U.S. Serial No. 09/960,297 -- 3

REMARKS

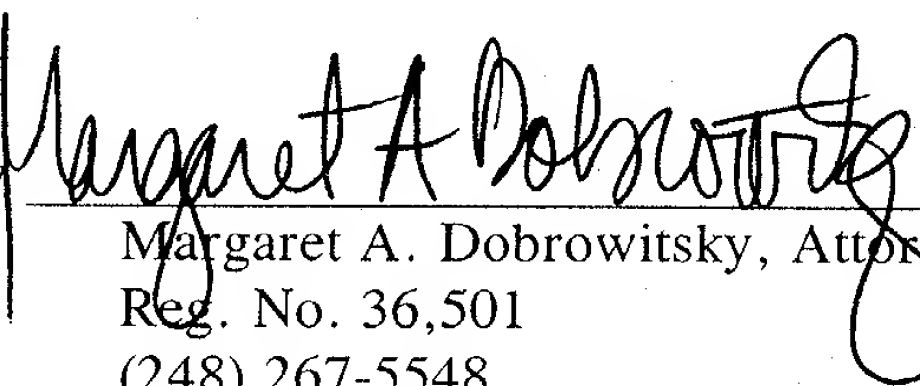
Drawing FIG. 7 is amended for consistency with references to the figure on pages 3 and 5 of the specification which describe a five phase winding without reference to A and B parts. The drawing is amended to delete references to a second set of winding parts. FIG. 11 and the accompanying description on page 6 of the specification describe the alternative of a winding having A and B parts.
